Remarks:

Applic. No. : 09/363,277

Claim 8 (amended). A method for producing a trench capacitor, which comprises the following steps:

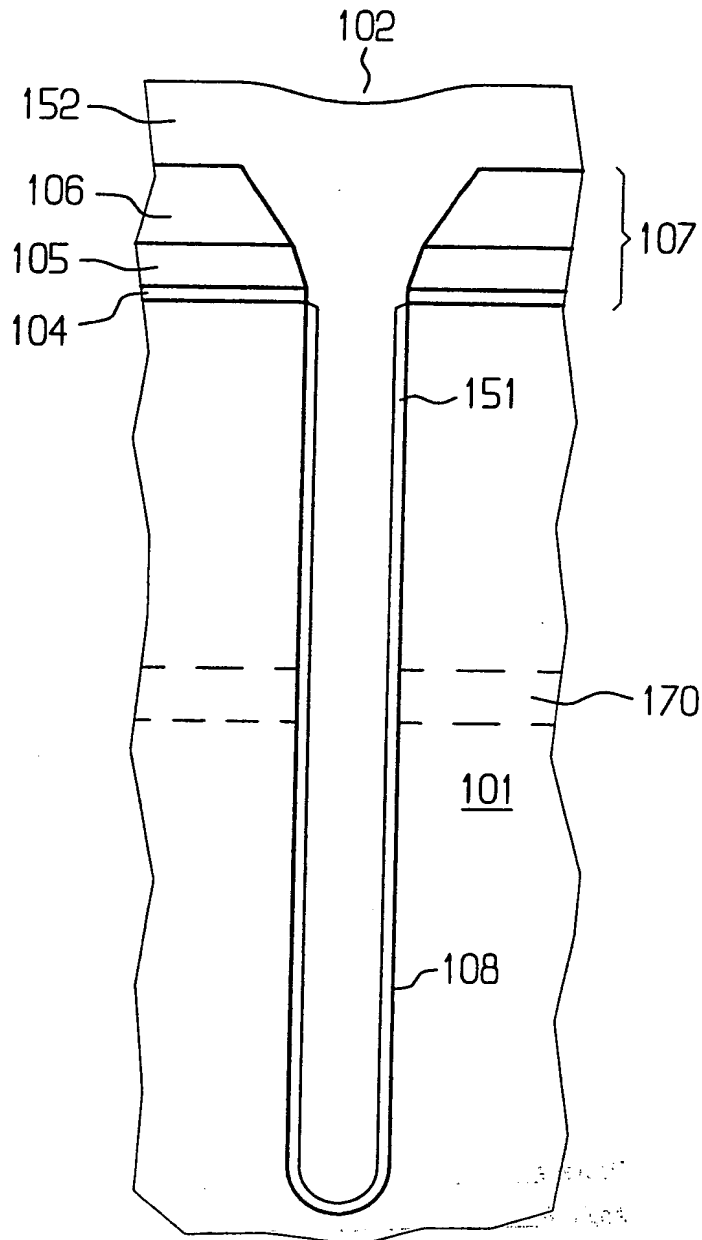
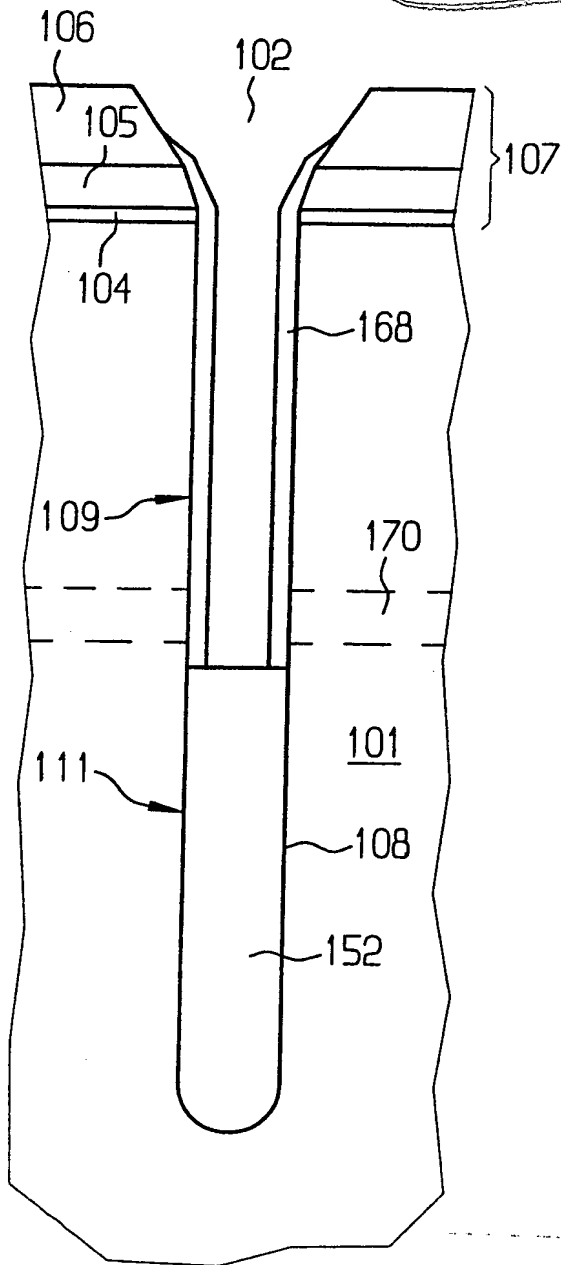
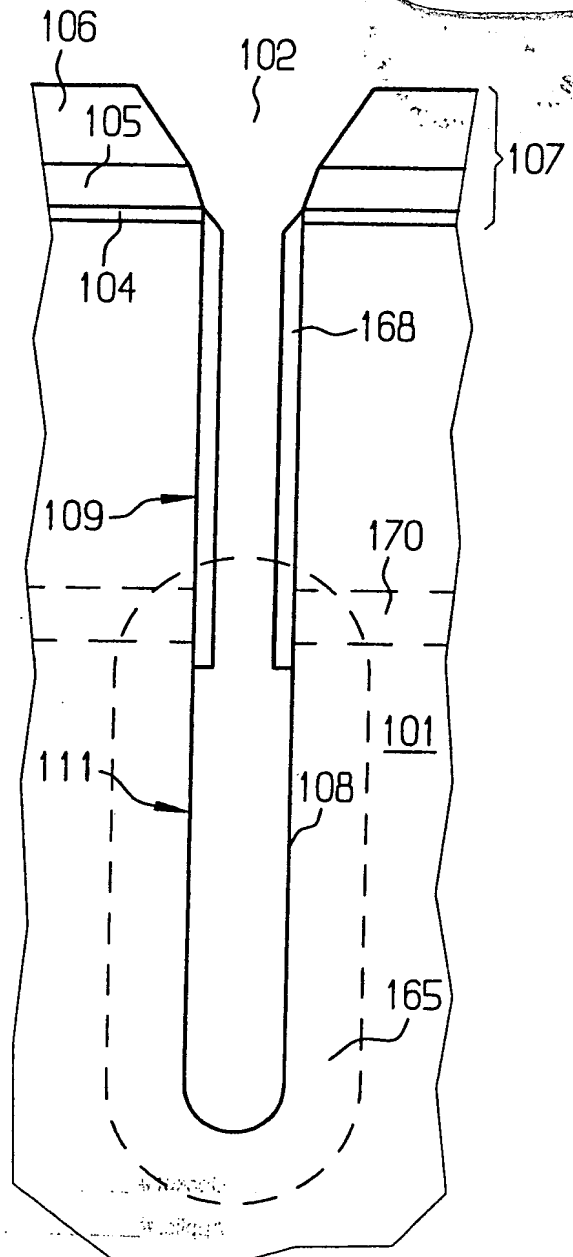
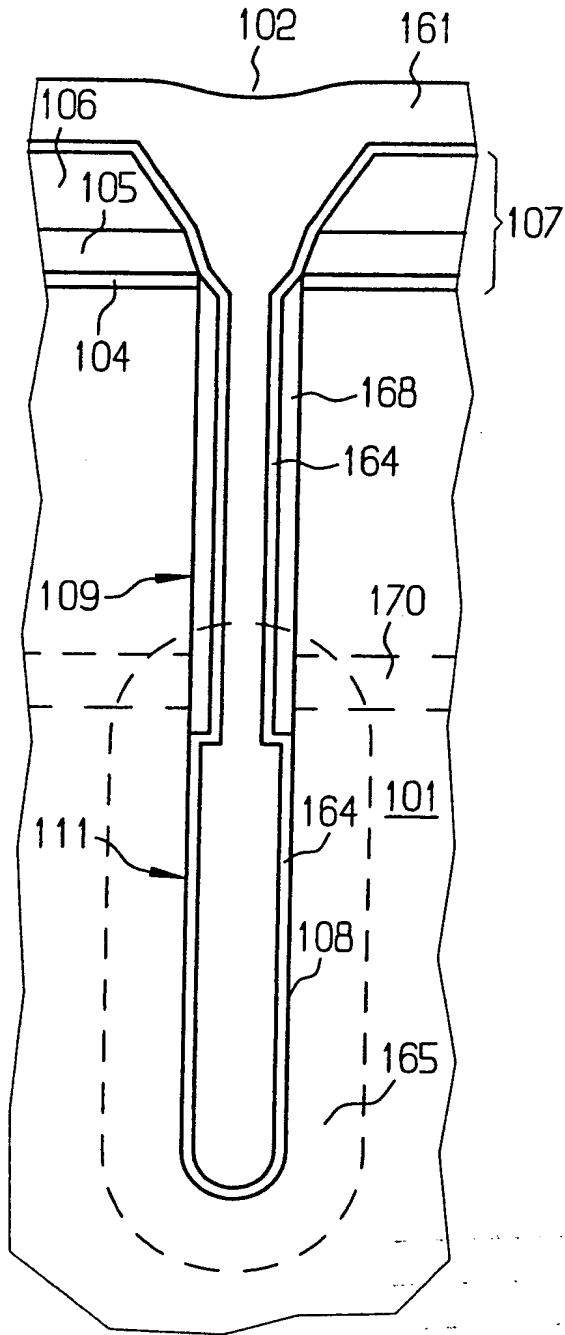
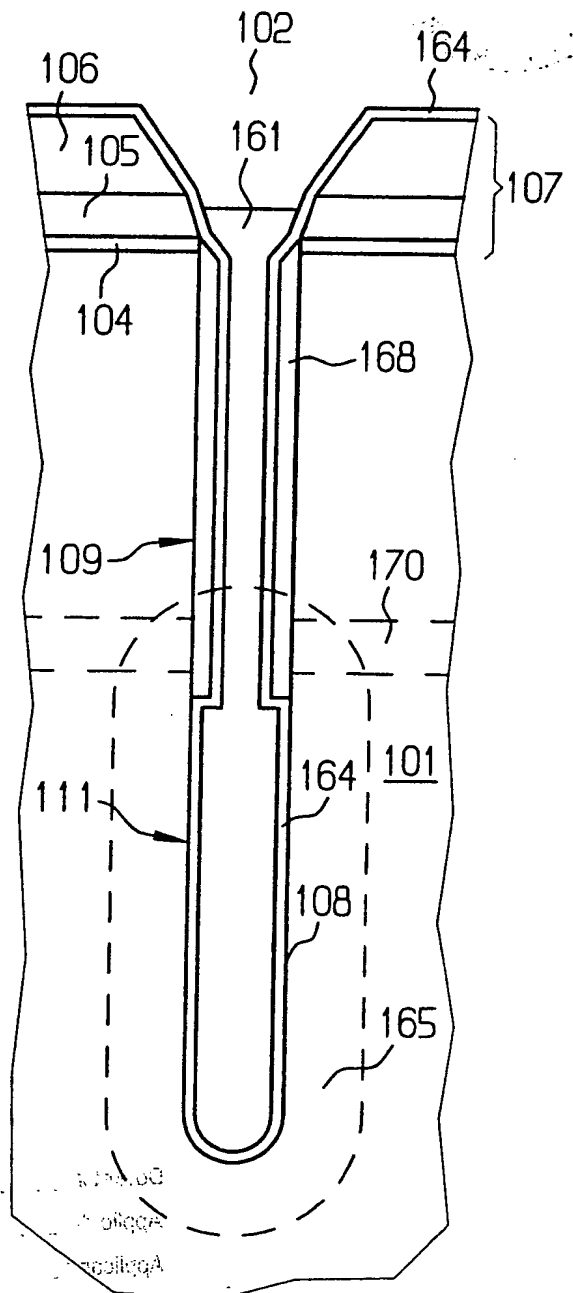
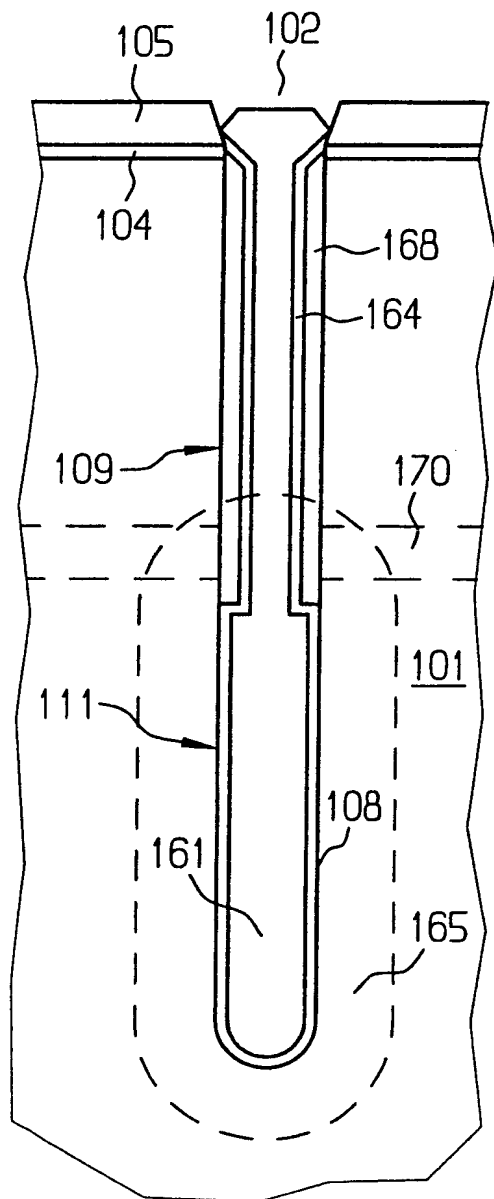
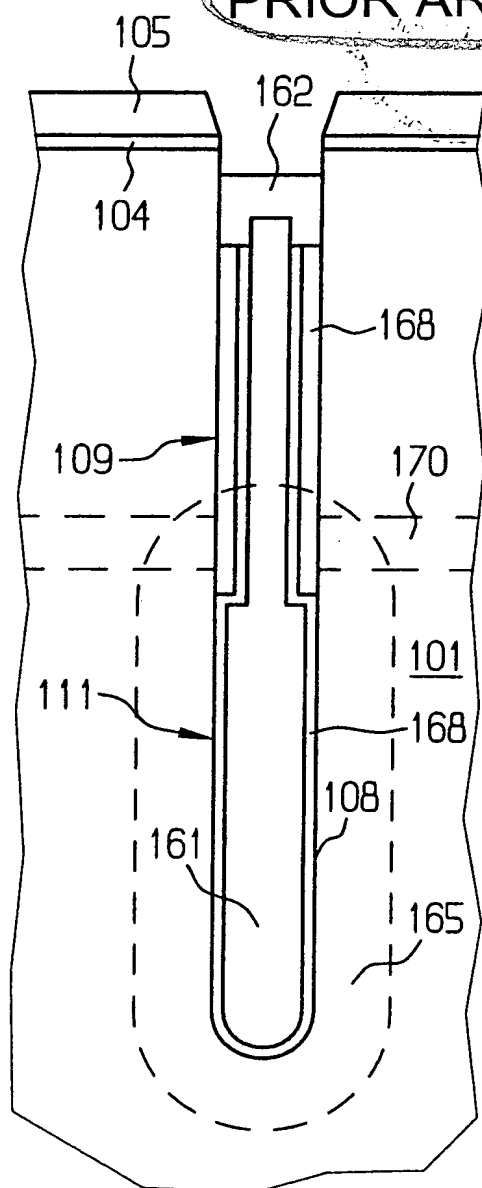
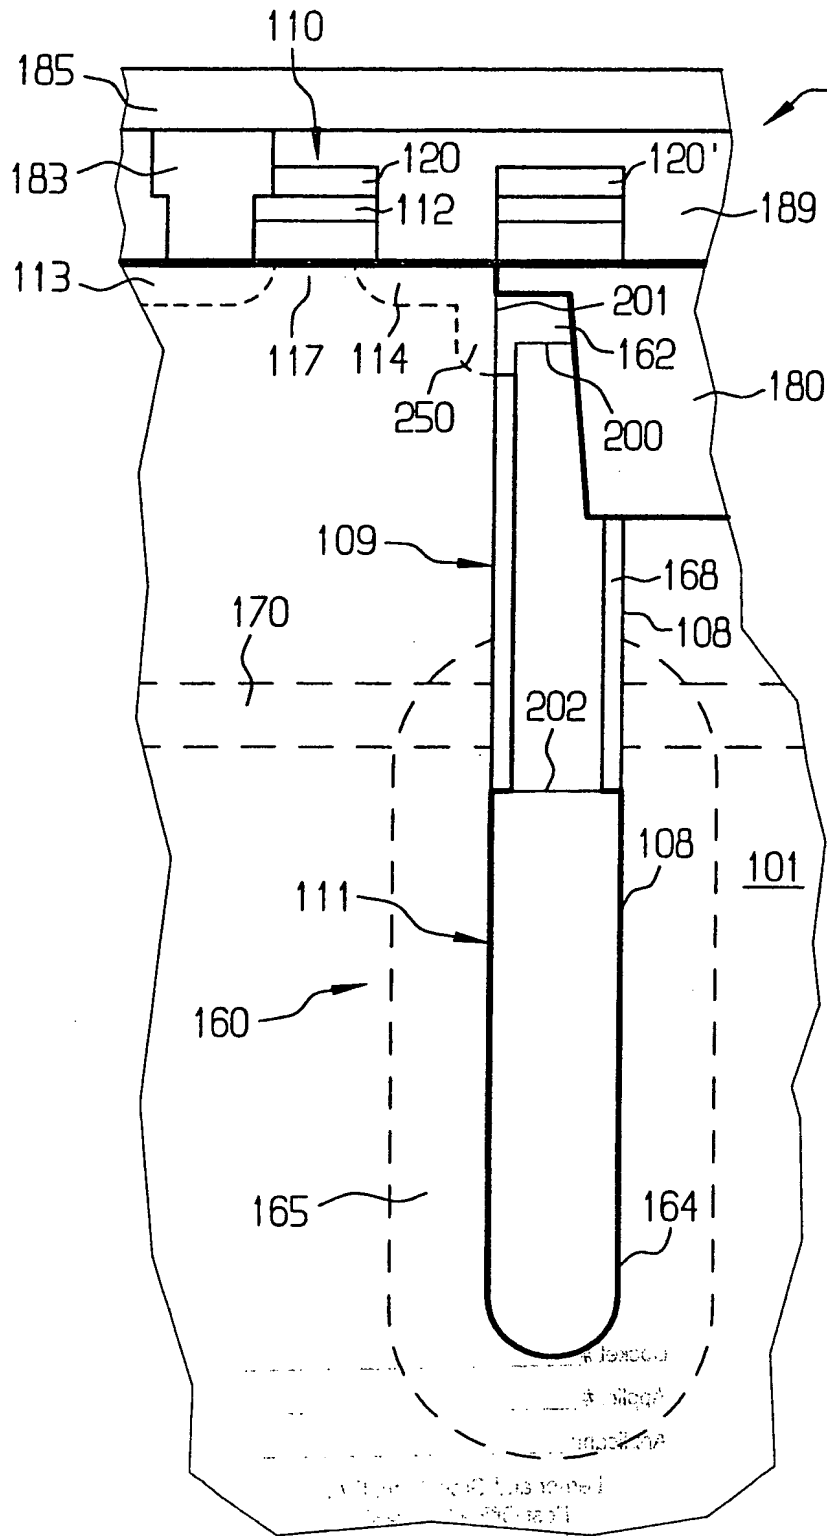
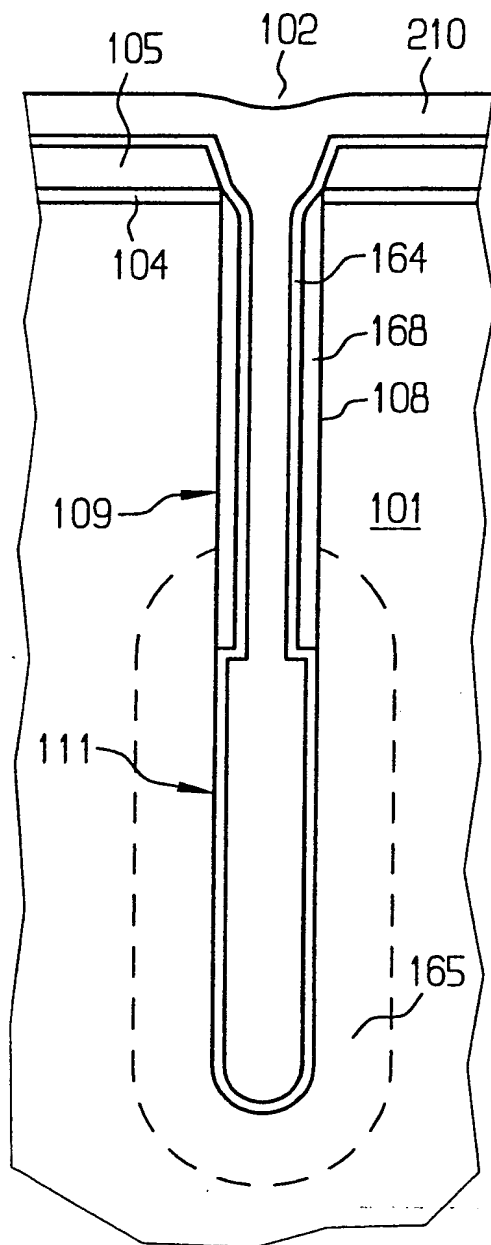
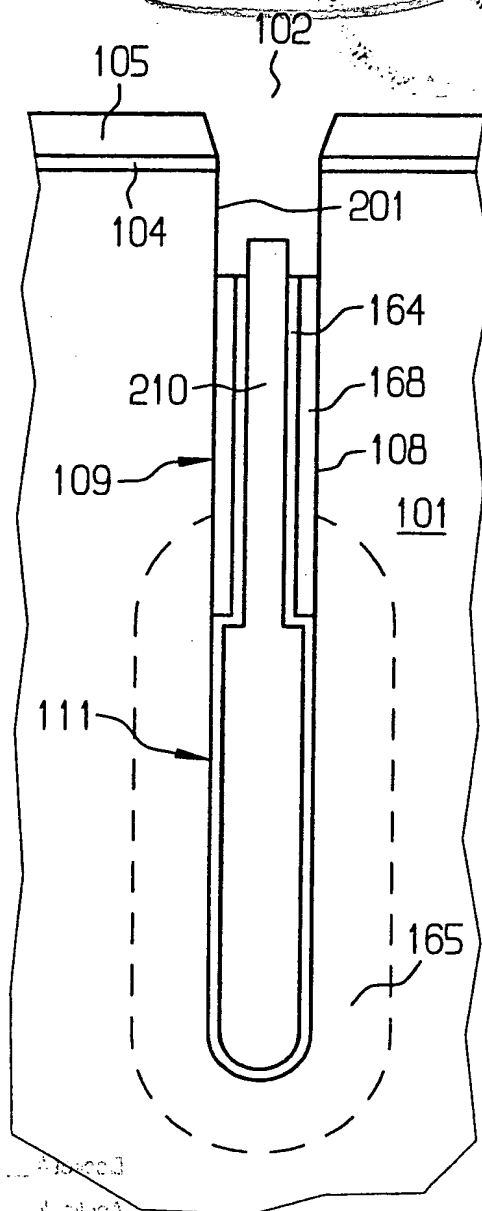
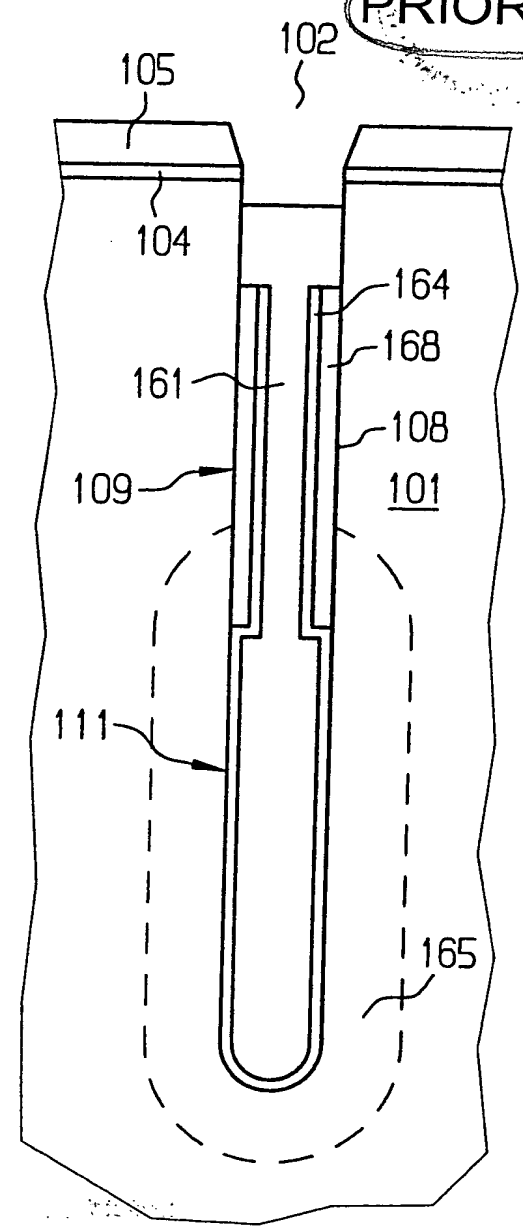
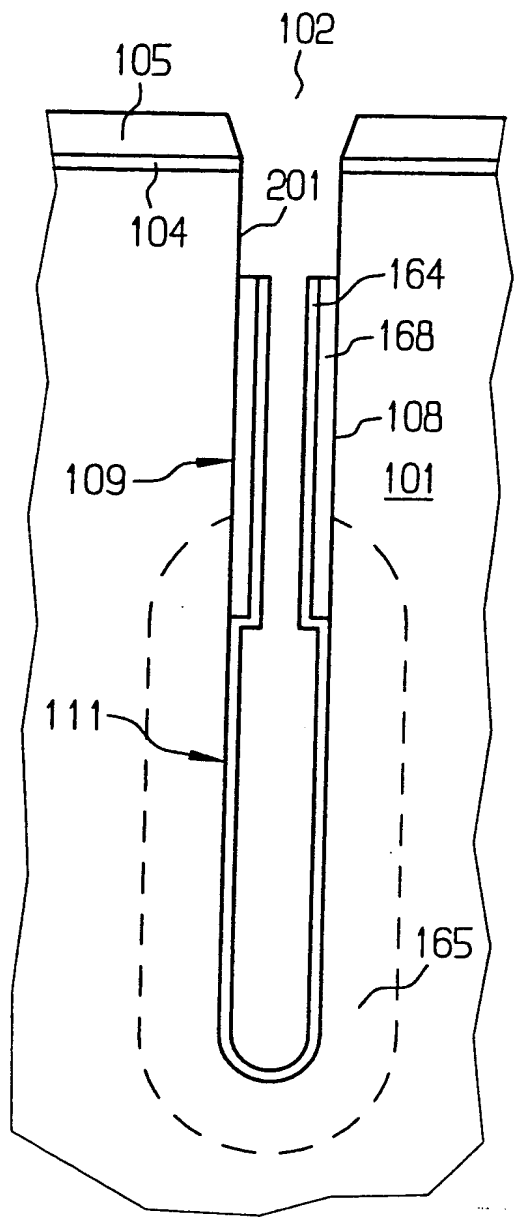
In the second paragraph on page 3 of the Office action, Figs. 6-12 of the drawings were objected to as not containing a legend such as --Prior Art--. Figs. 6-12 of the drawings were corrected as suggested by the Examiner. New "final" drawings of Figs. 6-12 are enclosed.
